# **Lime Down**

Solar Park

## **Change Application and Consultation Report (Change Application)**

**Document Reference: EXAM/9.40**

**Proposed Site Access Route**

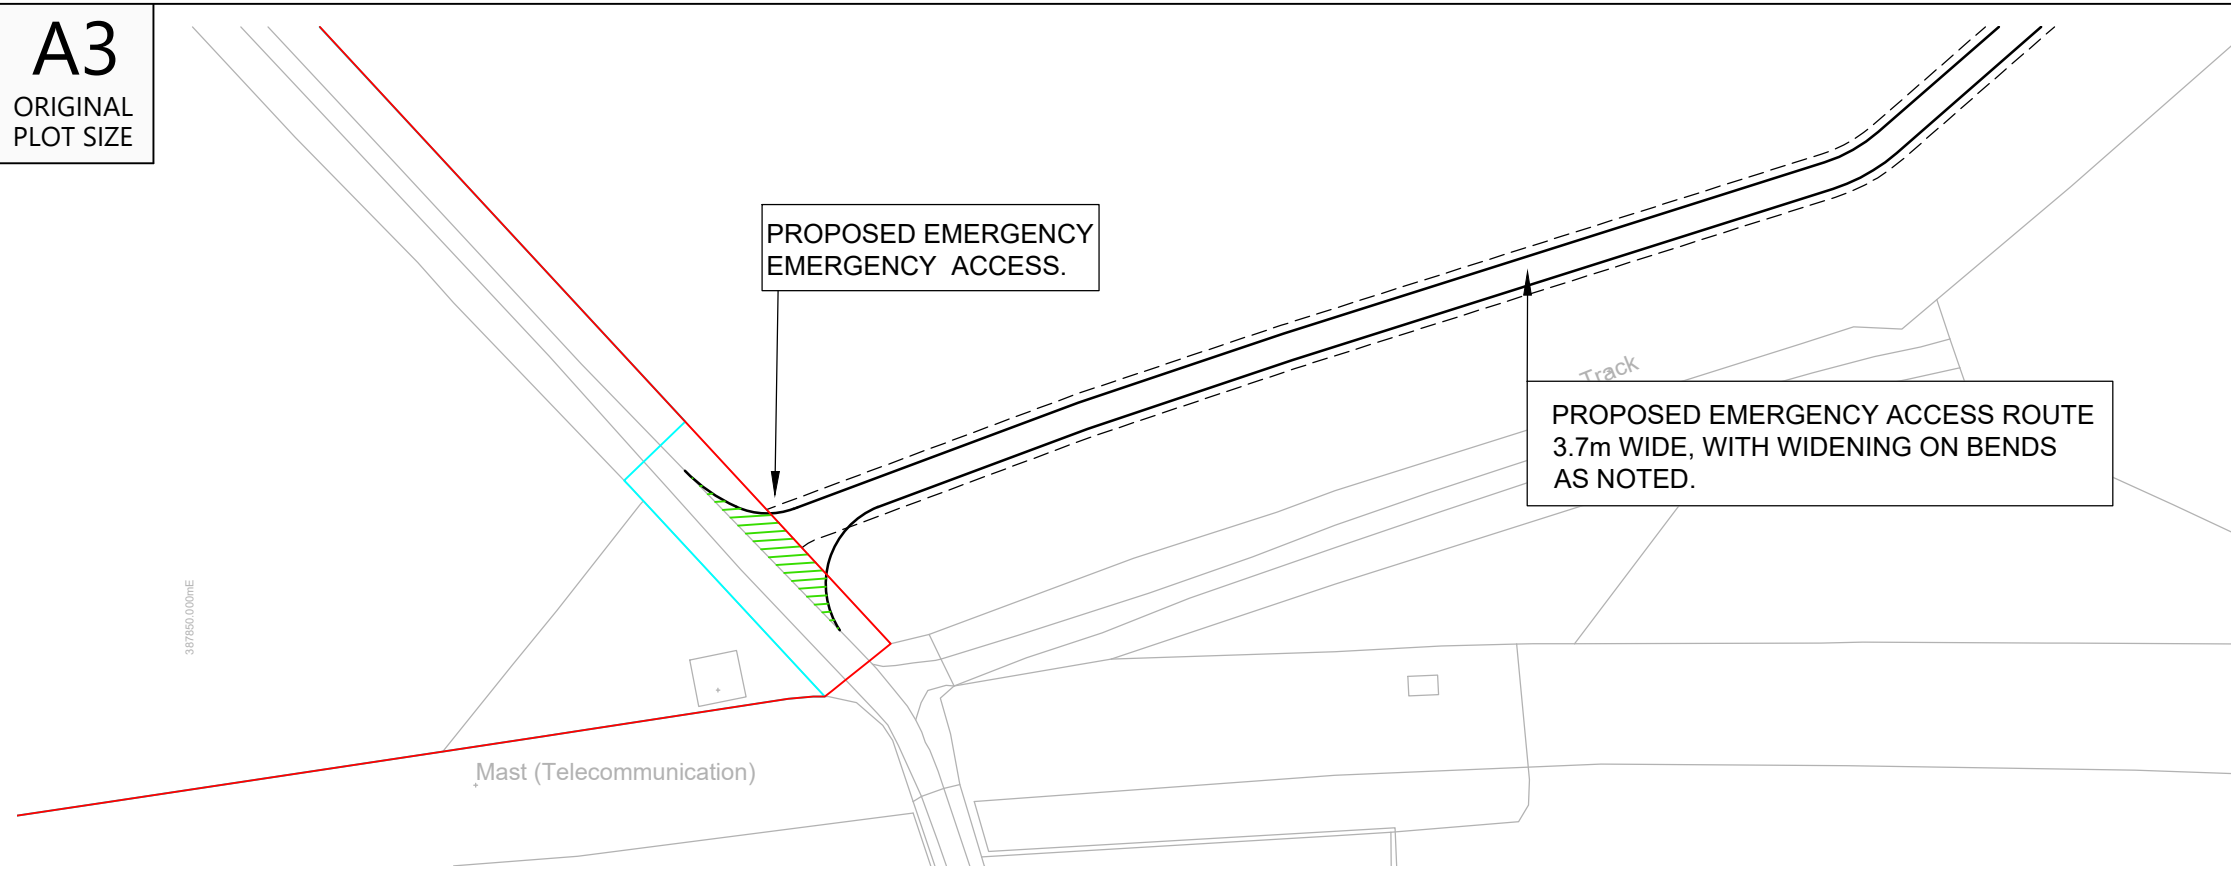
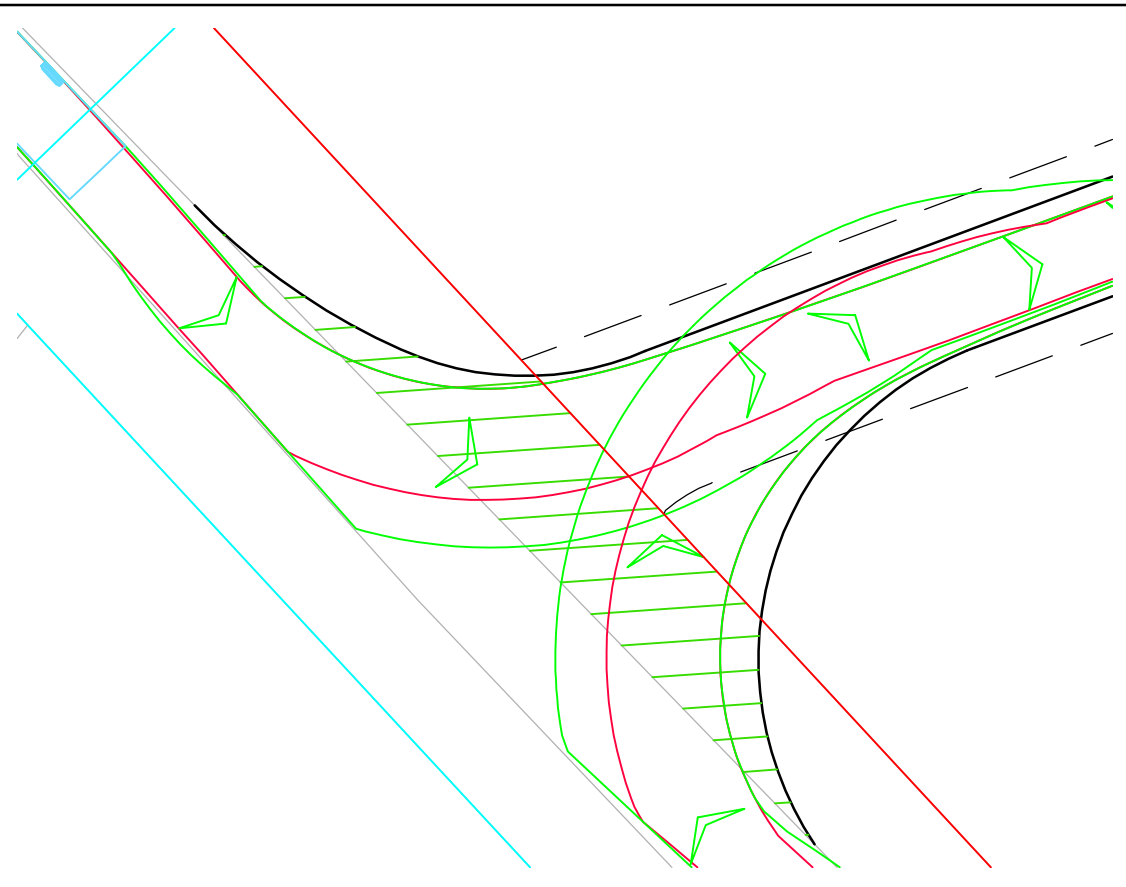
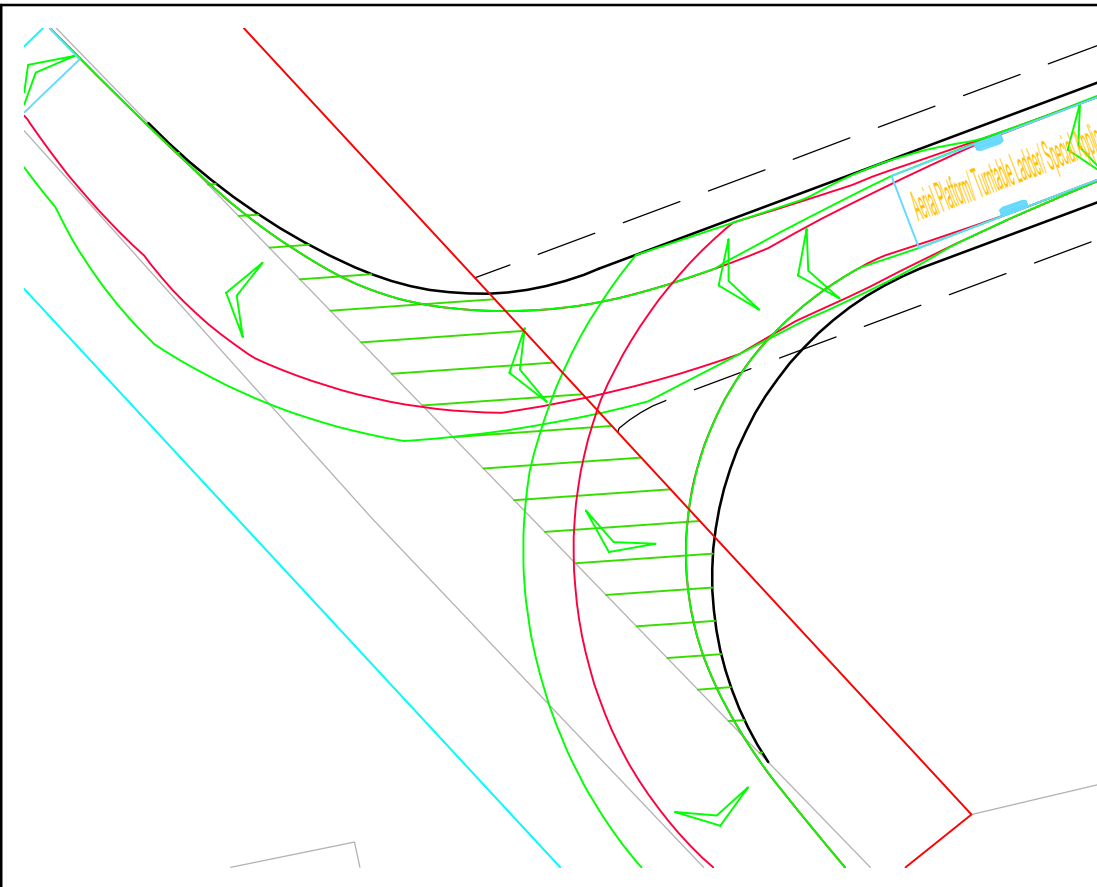
Rev	Date	Details	Drawn by	Checked by	Approved by
A	28.05.26	Proposed Order Limit updated	AS	JD	JD
